#### 49 CFR Parts 571 and 596

#### Federal Motor Vehicle Safety Standards; Child Restraint Systems, Child Restraint Anchorage Systems

**ACTION:** Final rule, response to petitions for reconsideration.

Figure 17- Side, Back and Bottom Views, ISO 13216-1 Static Force Application Device 2 (SFAD 2)

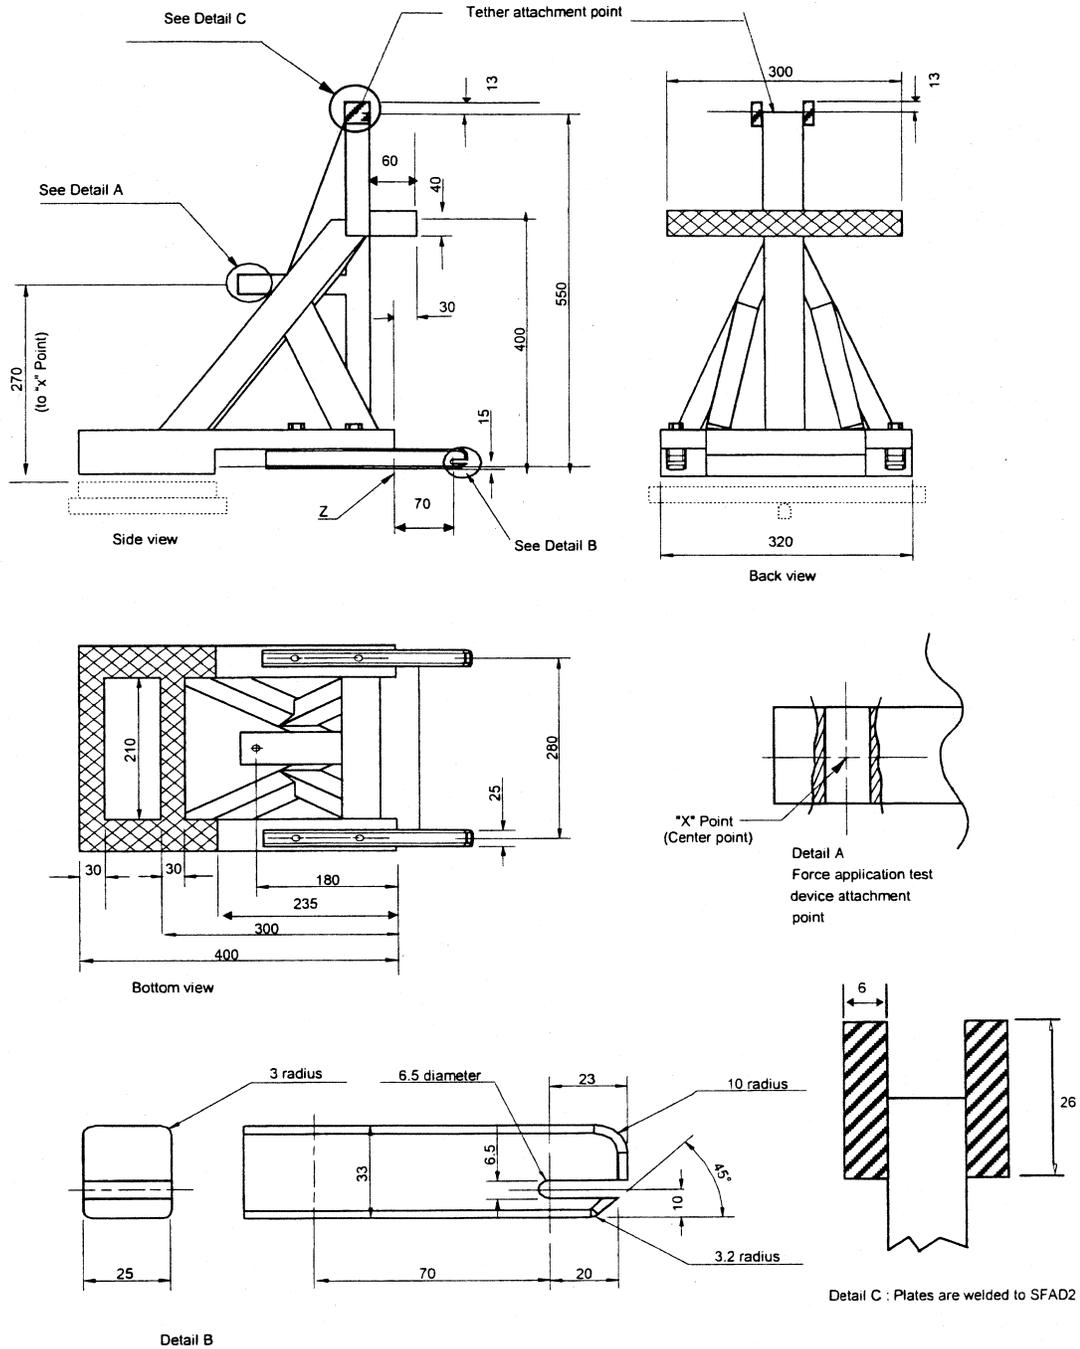
i. SFAD 2. In a petition for reconsideration, Mitsubishi noted that Figure 17 of FMVSS No. 225, which depicts the dimensions of the SFAD 2 test device, only specifies a tether attachment point somewhere near the top of the device. Mitsubishi believed that leaving the specific location of the attachment point and the shape and radius of the hole to the discretion of each vehicle manufacturer and test laboratory will lead to wide variation in the loading conditions in tether anchorage testing. Mitsubishi requested NHTSA to identify specific requirements for the location and dimensions of the SFAD 2 tether attachment point.

We have revised Figure 17 to make it clear that the tether attachment point on SFAD 2 is the same as on the SFAD 1 test device depicted in Figures 12 to 15 of FMVSS No. 225, both in location and dimension.

Figure 21—Length of Lower Anchorages

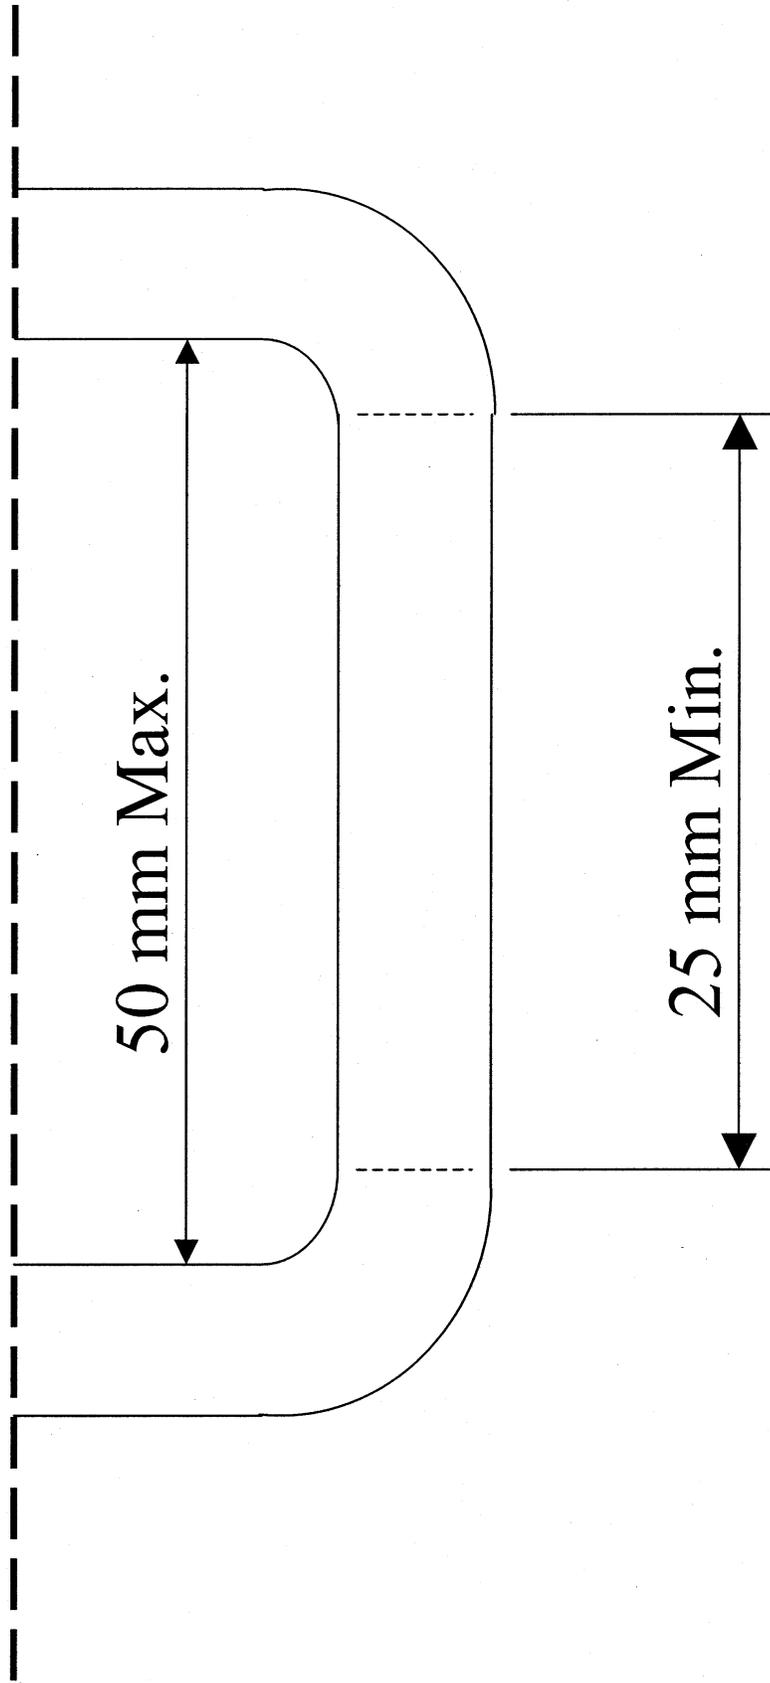
S9.1.1(c) specifies that the lower anchorages must be not less than 25 mm, but not more than 40 mm in length. The limits were adopted in part to standardize the design of the lower bars. The 40 mm maximum length specification was also adopted to reduce the likelihood that the bars may bend in a crash. The Alliance and Porsche petitioned the agency to delete the 40 mm maximum length limit as unnecessary. Petitioners believed that as long as the anchorages meet the strength test requirements of the standard and can accommodate the CRF, the limit is

Bornemann Products Incorporated asked whether the "not less than 25 mm but not more than 40 mm" language in S9.1.1(c) refers to the inside opening of the anchorages (bars), or to the overall length of the bar including the 6 mm steel material. The answer is the inside opening of the bar, and not the overall length of it. We are adding a figure to the standard to clarify the meaning of S9.1.1(c).

NHTSA has decided not to delete the maximum length specification. We believe that limiting the length of the anchorage bars will contribute towards better performance of a child restraint in a side impact. NHTSA conducted side impact sled tests in response to the Transportation Recall Enhancement, Accountability and Documentation Act (the TREAD Act) (November 1, 2000, Pub. L. 106-414, 114 Stat. 1800). See Docket No. 02-12151. These simulations showed that limiting lateral movement and/or rotation of a child restraint in a side impact is important to reducing occupant head excursion in the crash and the likelihood of head impact against the vehicle side structure. We believe that limiting the length of the bars will limit the chances that the bar will bend in a crash, and will limit the ability of a child restraint to move laterally and/or rotate in a side impact. The effect cannot be quantified at this time. Moreover, limiting the length of the bars also increases the uniformity of appearance to consumers. However, to provide more design and manufacturing flexibility to manufacturers, this rule increases the maximum bar length from 40 mm to 50 mm.

- (b) Are straight, horizontal and transverse;
- (c) Are not less than 25 mm, but not more than 50 mm in length (as shown in Figure 21);
- (d)-(e) [Reserved]
- (f) Are part of the vehicle, such that they can only be removed by use of a tool, such as a screwdriver or wrench; and

Figure 22. Placement of Symbol on the Seat Back and Seat Cushion of a vehicle

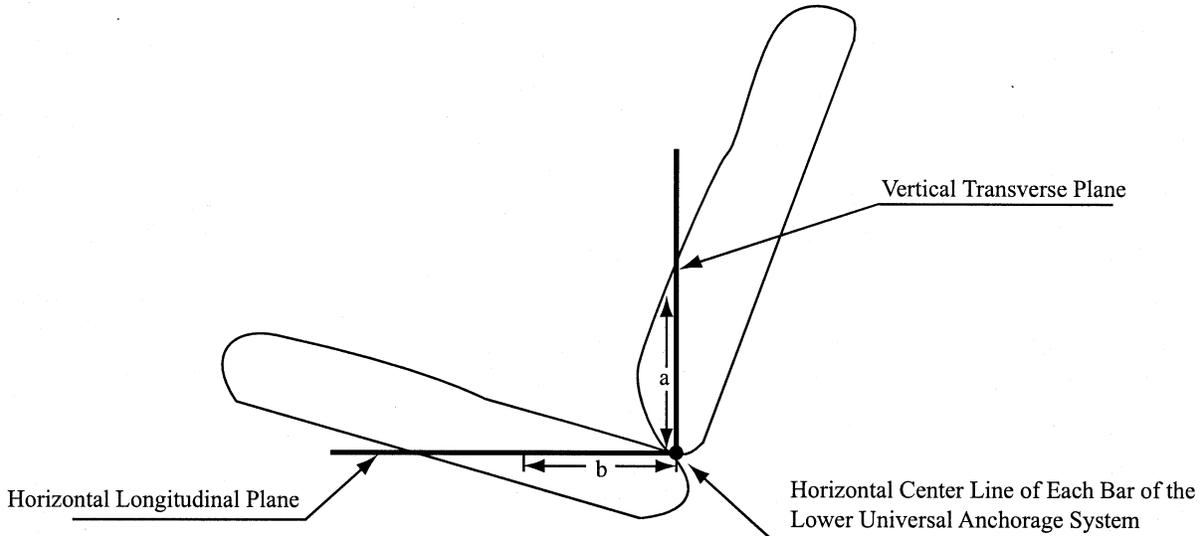
Mitsubishi believed that consumers would be better assisted in locating the anchorage bar if the 50 mm lower limit for location of the anchorage bar mark were eliminated. The Alliance believed that the vertical position of the marking should be less restrictive than what the rule required. "It should be visible at a 30 degree viewing angle and be located no more than 100 mm from the horizontal centerline of the anchorage bar in the vertical longitudinal plane." Mitsubishi and the Alliance asked where the "seat back" begins for the purpose of marking the lower anchorages on highly contoured seats. Mitsubishi stated that the bottom cushion of some of its seats curves toward the vertical and supports a portion of an occupant's lower back before a separate seat back begins. Petitioner stated that if the agency considers a portion of a vehicle seat to be the seat back solely by reference to a physical separation between the bottom seat cushion and the seat back, the circle markings would be more than 75 mm above the anchorage bars, which is not permitted by S9.5(a)(3).

To make it easier to find where the circles should be placed, the agency is amending S9.5(a) to use reference planes developed by Transport Canada in Regulation 210.2, "Lower Universal Anchorage Systems for Restraint Systems and Booster Cushions" (Standard 210.2). That standard requires the markings to be on the seat back between 50 and 75 mm above or on the seat cushion 100 ± 25 mm forward of the intersection of the vertical transverse and horizontal longitudinal planes intersecting at the horizontal centerline of each lower anchorage. This approach is not only clearer in where the circles should be, but also permits the markings to be located either on the seat back or the seat cushion, which allows flexibility to manufacturers such as Mitsubishi with atypical seat designs. The area 100 ± 25 mm forward of the

intersection of the planes is specified to account for the lower anchorage bars being recessed in the padding of the seat back or recessed in the seat bight. This final rule incorporates a figure (Figure 22) into the standard that illustrates the intersection of the vertical transverse and horizontal longitudinal planes.

(3) That is located such that its center is on each seat back between 50 and 75 mm above or on the seat cushion 100 ± 25 mm forward of the intersection of the vertical transverse and horizontal longitudinal planes intersecting at the horizontal centerline of each lower anchorage, as illustrated in Figure 22. The center of the circle must be in the vertical longitudinal plane that passes through the center of the bar (± 12 mm).
